*Private Fuel Storage, L.L.C.*

July 20, 2001

**MAP CORRECTION: JULY 18, 2001 SUBMITTAL**  
**DOCKET NO. 72-22 / TAC NO. L22462**  
**PRIVATE FUEL STORAGE FACILITY**  
**PRIVATE FUEL STORAGE L.L.C.**

Typo in Lat/Long DATA

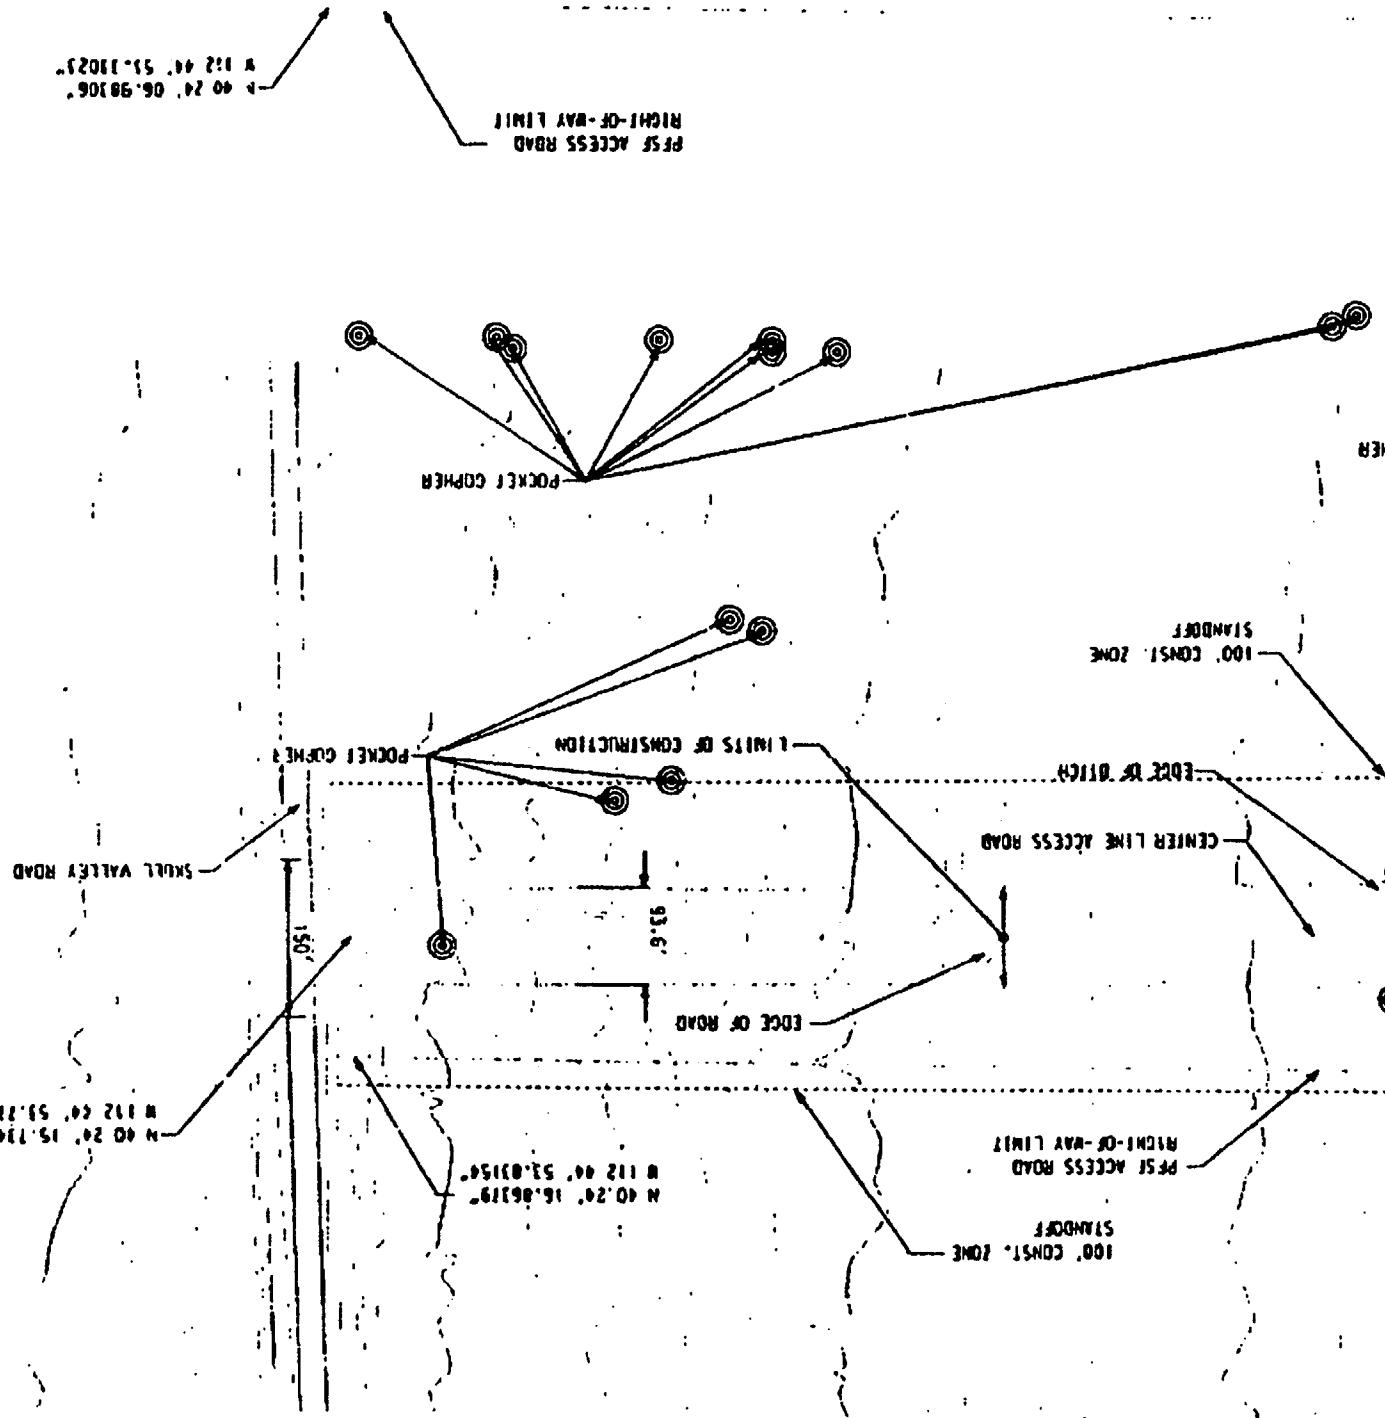
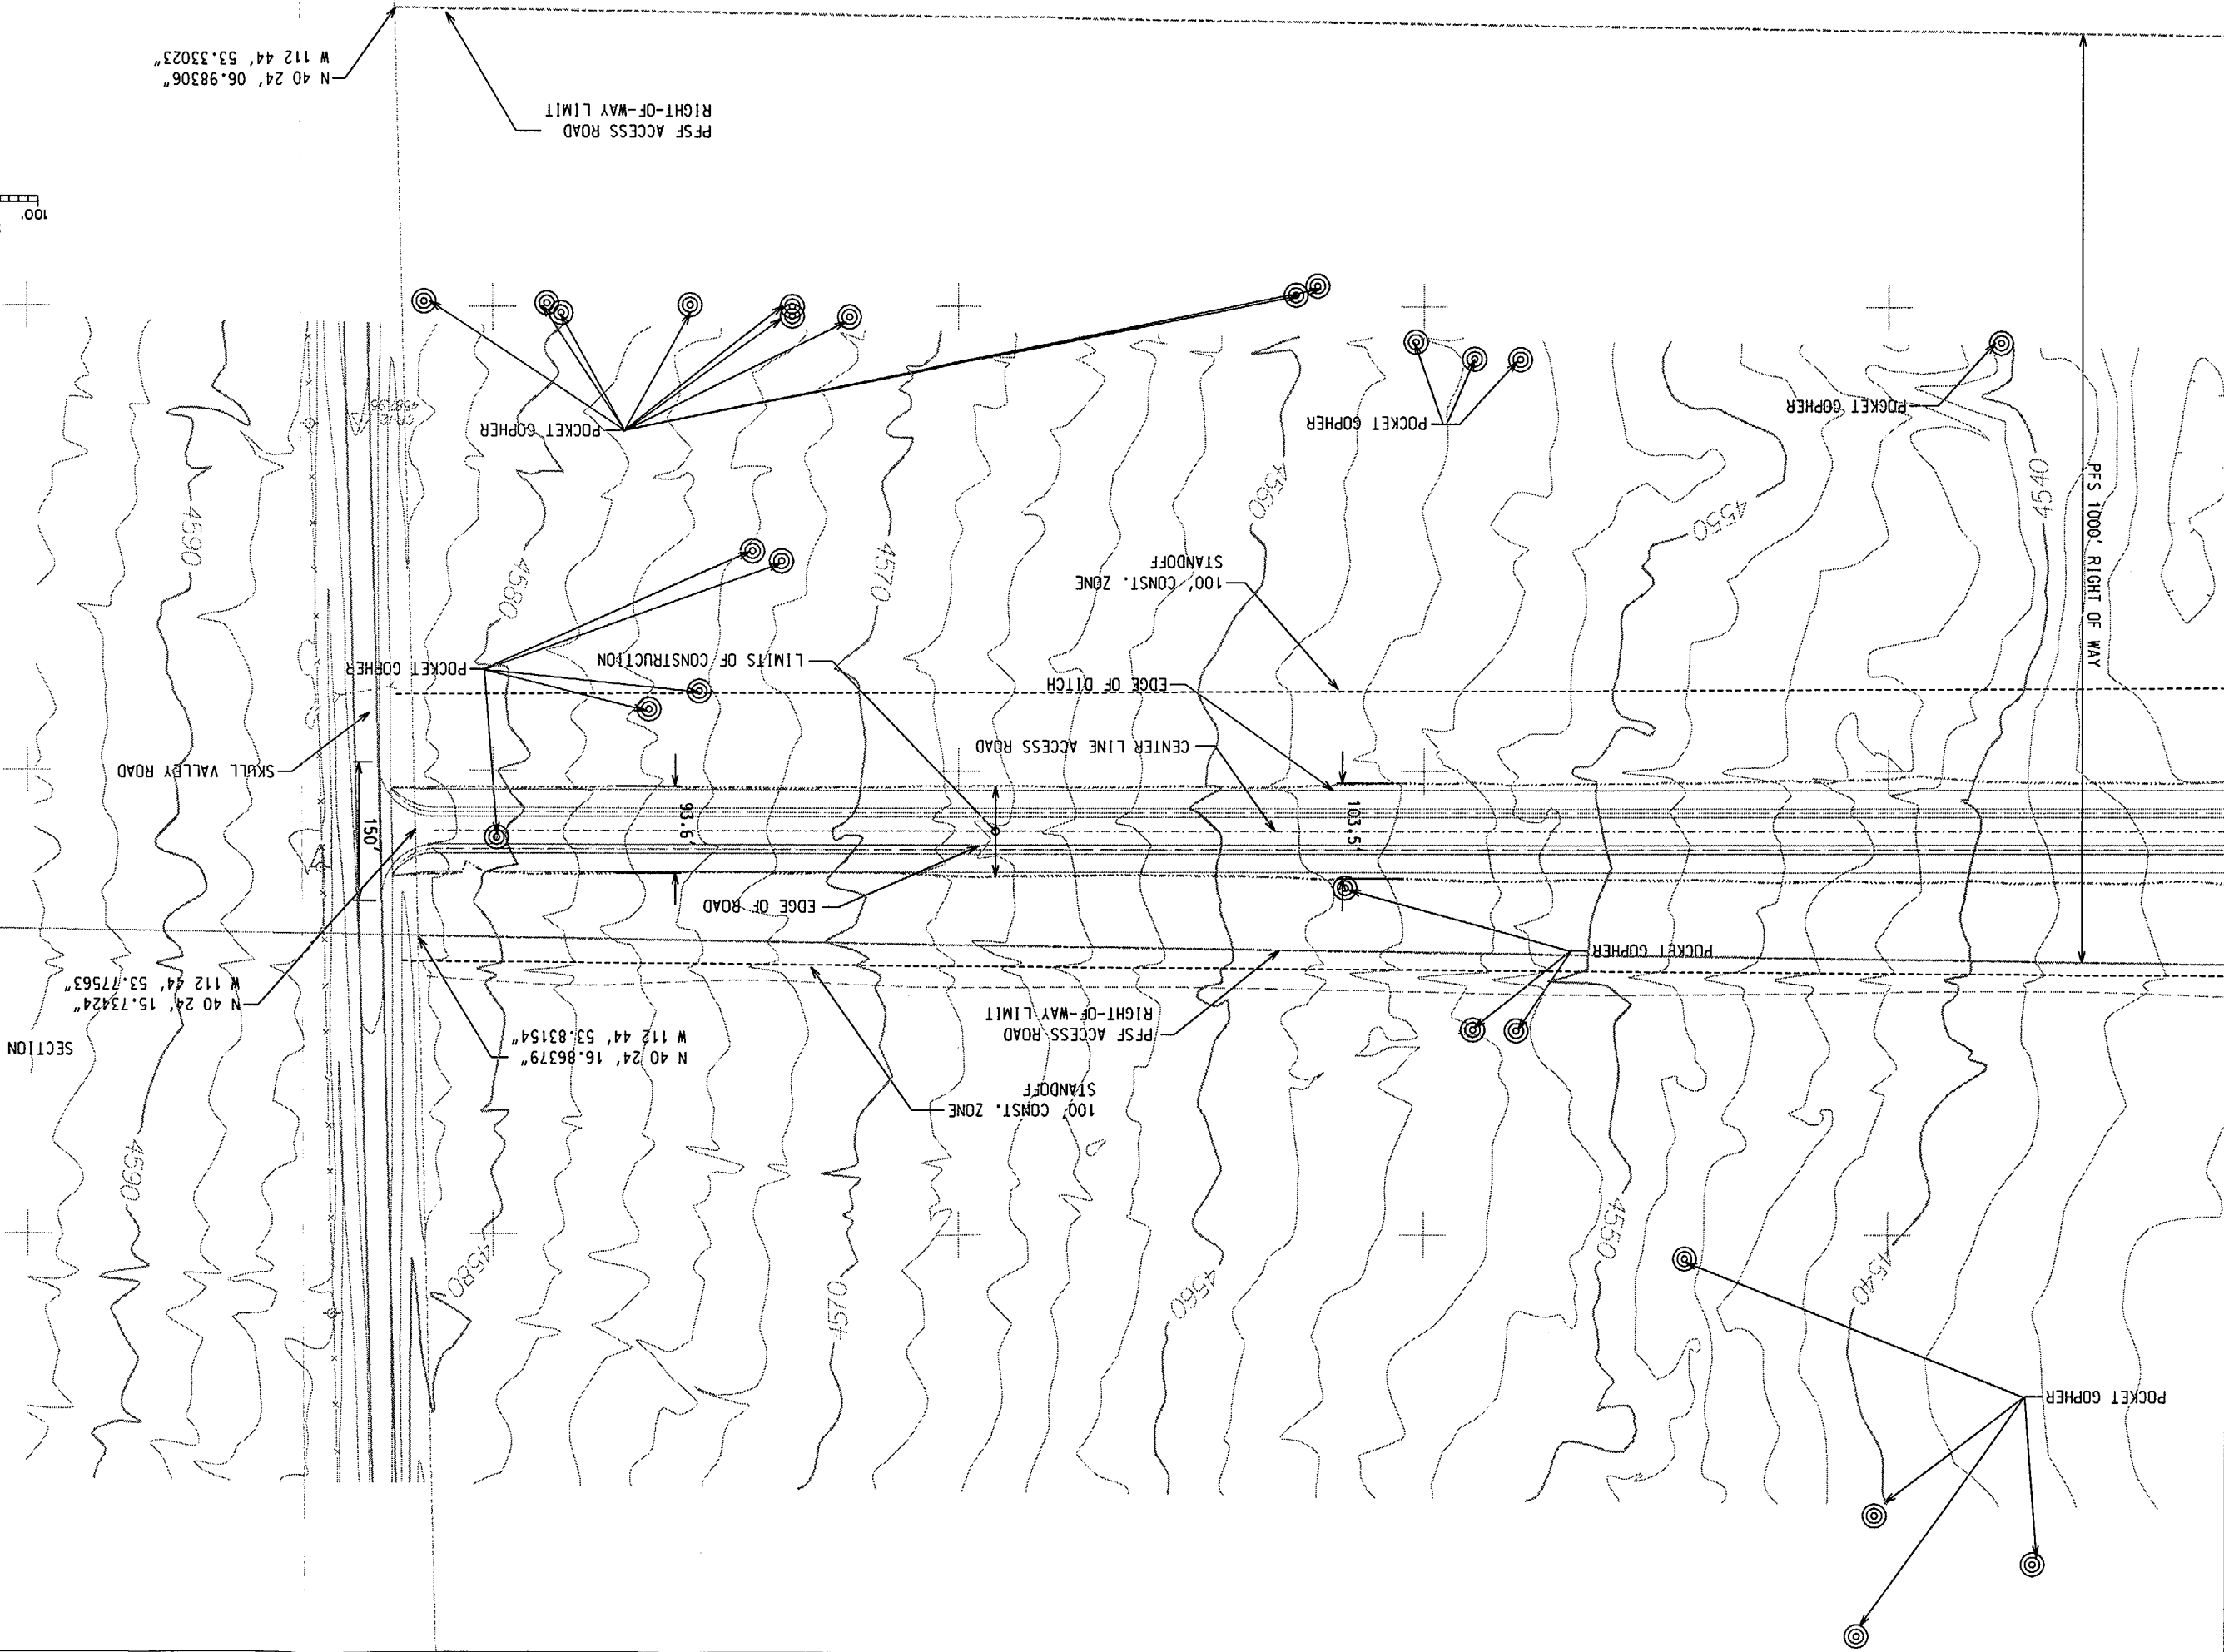
Stone & Webster provided reference material earlier this week (Reference 1) per an NRC request. It was noted that three data points in the reference material were erroneously identified by Dr. Pritchett with regard to their latitude/longitude location. Although these three points fall beyond the construction zone, PFS attempted to correct the information based on a locational description from Dr. Pritchett. However, the translation of these three points was not properly portrayed on the included map.

Attached with this letter is a corrected map showing the following three data points at their proper location. The three points remain outside of the construction zone. The PFS Environmental Report will be updated in the future to include the relevant reference material supplied to the NRC as discussed with Mr. M. Delligatti - NRC on July 19, 2001.

Pritchett - Original

N 40 24 09.1  
W 112 44 16.0

N 40 24 10.9  
W 112 44 01.9

N 40 24 11.1  
W 112 44 26.0

Corrected

N 40 24 10.5  
W 112 45 09.0

N 40 24 10.6  
W 112 45 08.4

N 40 24 10.4  
W 112 45 07.6
